Deleted: 1
Deleted: October
Deleted: 3
Inserted: October 23, 2001

Emergency Preparedness  
Significance Determination Process

Sheet 2

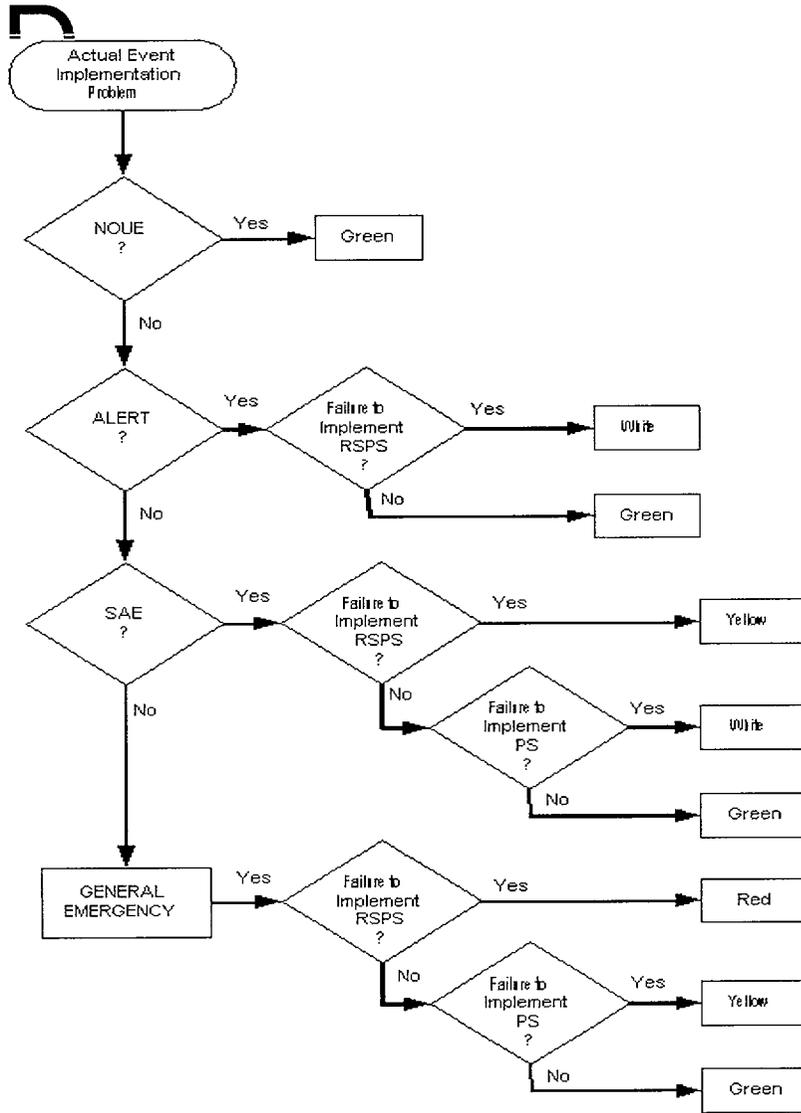
**Proposed Revision to EP SDP**  
**Failure to meet Regulatory Requirement**  
(This line replaces left line sheet 1 Failure to meet Regulatory Requirement)
